## PLANNING COMMITTEE MEETING No. 236

### 2.1. PP-935-2020 – 34 Barrabool Road, Highton

**Application No:** PP-935-2020

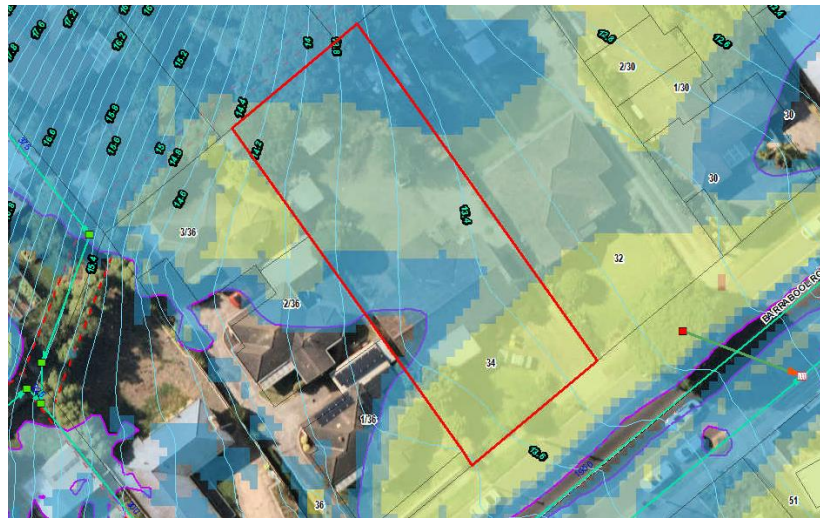
basement access (footpath) has been shown on the Ramp Section as 13.616 which is deemed to be to AHD.

The onsite and offsite increase in flooding reported in Flood Impact Assessment (FIA) are unacceptable (below map). For a development in SBO, the City has 'no-adverse impact' policy. The increase in flooding onsite within the proposed building footprint does not make sense, indicating that the building has not been incorporated properly. Therefore, the modelling needs to be re-done to determine the appropriate flood levels, risks and impact.

According to the SBO flood study, the applicable flood level for the ramp access is 13.60m AHD. The proposed floodgate top/highest level is set at 14.06 m AHD (figure below) – 300 mm above the flood level resulted from the FIA. This level needs to be re-assessed based on re-modelling as per above.

1. Prior to the commencement of the development, amended plans and Flood Impact Assessment report to the satisfaction of the Responsible Authority must be submitted to and approved by the Responsible Authority. When approved, the documents will be endorsed and will then form part of the permit. The documents must be generally in accordance with those submitted with the application but modified to show:

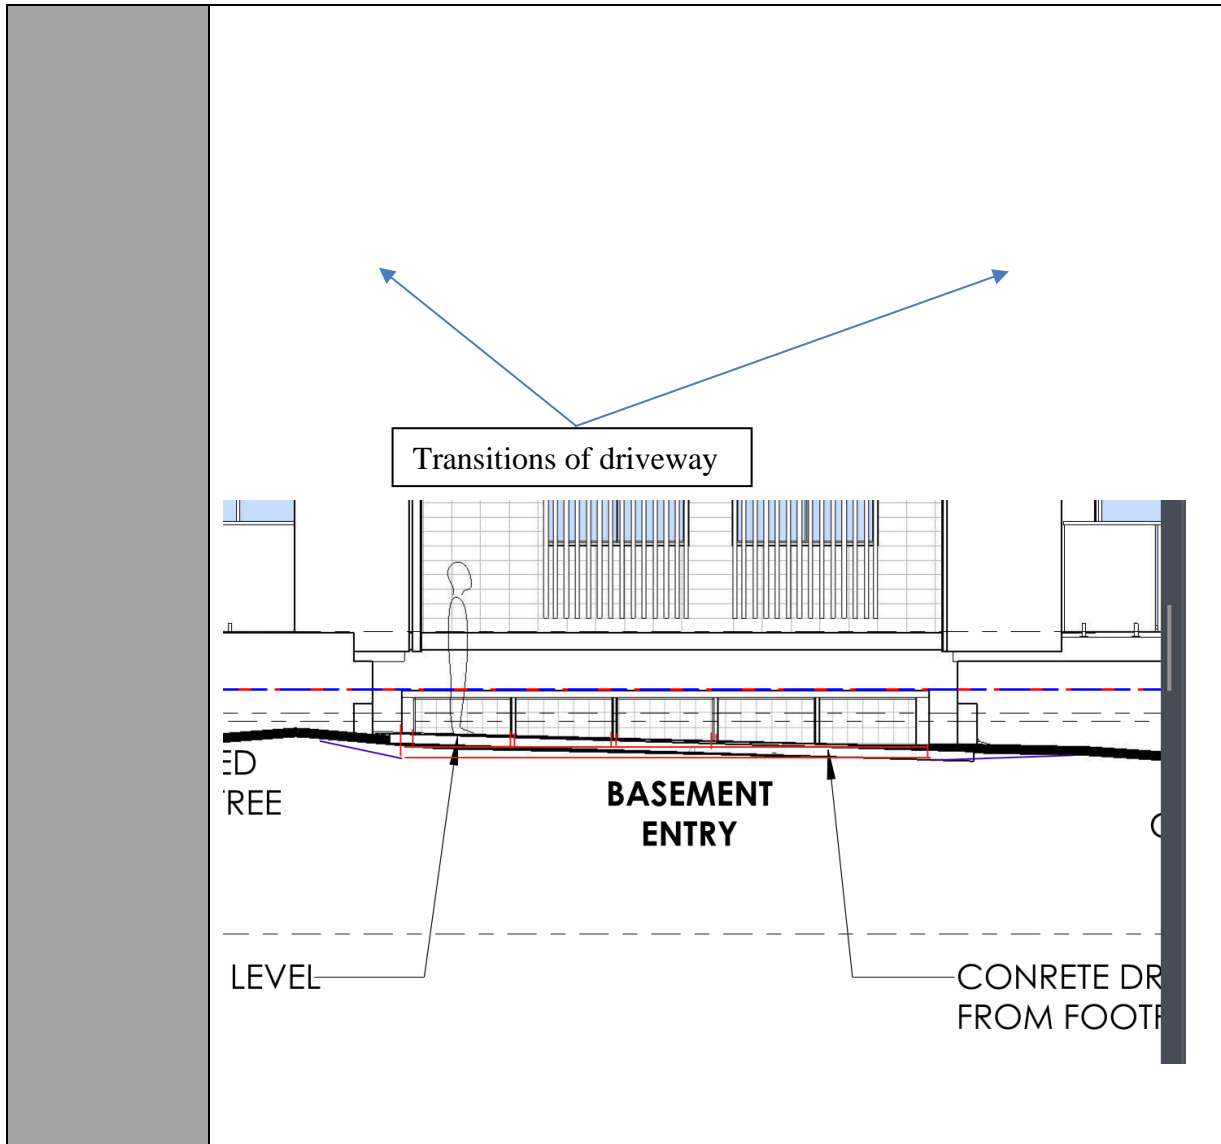
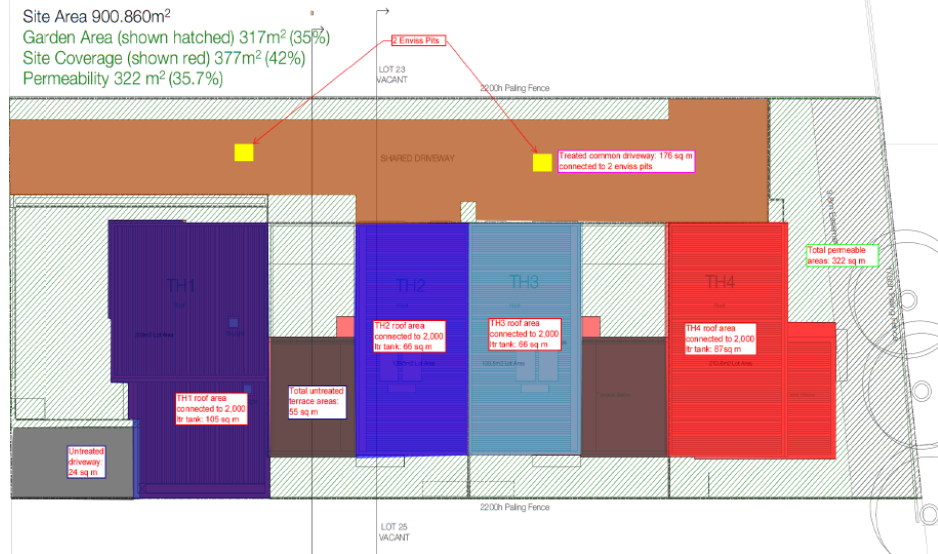
<b>Department:</b>	<b>Engineering Services</b>
<b>Response:</b>	<p>Ramp design does not achieve a one in ten (10%) grade for the first five metres and considered unsafe for pedestrians and vehicle access.</p> <p>The vehicle crossing does not achieve a minimum 1m clearance to the fireplug. Barwon Water need to provide written confirmation of the vehicle crossing within 1m clearance if this clearance cannot be achieved.</p> <div style="border: 1px solid black; padding: 5px; margin: 10px 0;"> <p><u>E-mail extract from Quantum Traffic advice:</u></p> <ul style="list-style-type: none"> <li>• <b>Initial Grade At Property Boundary:</b> As discussed, we can't get away from using 1:10, which is required to avoid cars scraping and to ensure that an exiting vehicle is reasonably flat when exiting to view pedestrians on the footpath. Whilst the technical requirement is 5m under the Planning Scheme, I have had luck in the past arguing 4m which is the length between the front of the B99 design vehicle and the rear wheels (see below).</li> <li>• <b>Length of Initial Segment:</b> Given that the property boundary is not perpendicular to the ramp, I have shown the NE side at the minimum 4m length and then set the SW side at 4.438m (slightly longer). This assists our design as the SW side is marginally higher than the NE side.</li> <li>• <b>Transition:</b> We need to provide a transition between the 1:10 and 1:4 as the change of grade would be too large (15% - it can only be a maximum of 12.5%). On the NE side the ramp grade will be 1:6 and on the SW side the ramp grade will be the maximum 1:4.5, so that the levels are same on each side at the end of this segment. The transition must be a minimum of 2m to avoid scraping.</li> <li>• <b>Main Ramp:</b> Main ramps is shown at 1:4 for 3.7m long.</li> <li>• <b>Bottom Transition:</b> This transition can be 1:8 rather than the 1:10 shown in your sketch. However, a minimum length of 2.5m is required to avoid scraping.</li> </ul> </div> <p>Extract from letter of response to grades does not match what the plan set shows where only the first 2.8m achieved a grade of one in ten (10%). Plans need to be in accordance with the Planning scheme requirements that the first 5m have a grade of one in ten.</p> <p><b>Sewer Vent adjacent to proposed new multi-level development.</b></p> <p>Barwon Water is required to make comment on the Sewer vent pipe and height of the proposed dwelling with respect to sewer miasma entering the living areas in the upper stories. The vent pipe may need to be modified.</p> <p><b>Floodgate Detail Requirement</b></p> <p>Engineering requires a detail plan to be submitted showing the floodgate setback by a minimum distance of 1m from the property boundary and how the driveway crossfall grades will transition to accommodate the floodgate that needs to be installed along a horizontal plane. It is noted there is a crossfall grade across the driveway and the driveway will need to transition, as needed, to accommodate the floodgate across a flat surface. An amended plans condition is included and a rough sketch provided.</p>

The traffic engineering report submitted with the application demonstrates that a revised ramp gradient design can accommodate safe access and egress of vehicle whilst maintaining sightlines for pedestrian safety.

Additional flood gate design detail has been provided to show that the gate can be installed 1m from the site boundary and maintain full function in accordance with the manufacturer's specifications and requirements.

Figure 23 (Above): Section showing the ramp grade for the accessway at ingress to the basement from Barrabool Road. Note, the vehicle illustrated is travelling in the wrong direction. Source: Application documents.

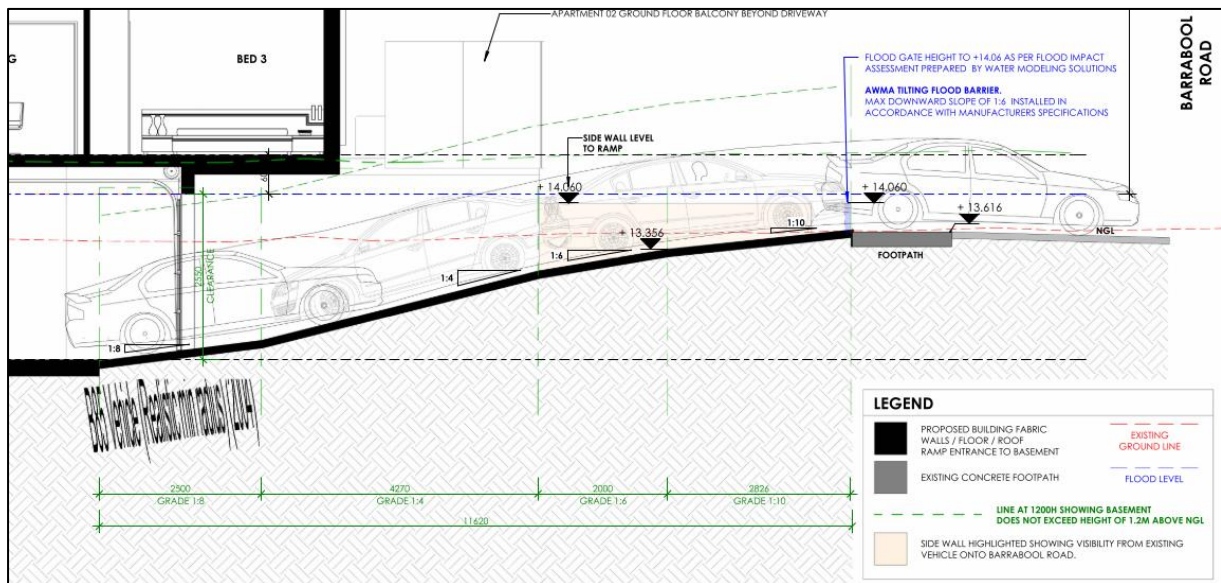
The access ramp proposes non-standard grades in the form of the following:

The traffic engineering report submitted as part of the application finds that the reduced minimum length of ramp grade at 1:10 at the top (2.521m instead of 5.0m) can continue to maintain safety for pedestrians and vehicles where the side walls of the ramp entrance are no greater than 0.9m in accordance with the sight-splay requirement. The sections and elevations show this area to remain clear of visual obstructions.

Similarly, the section of 1:6 gradient transition to 1:10 will minimise the risk of vehicle scraping that can otherwise occur if the grade change is too great. No vehicle scraping should normally occur at the top or the bottom of the access ramp.
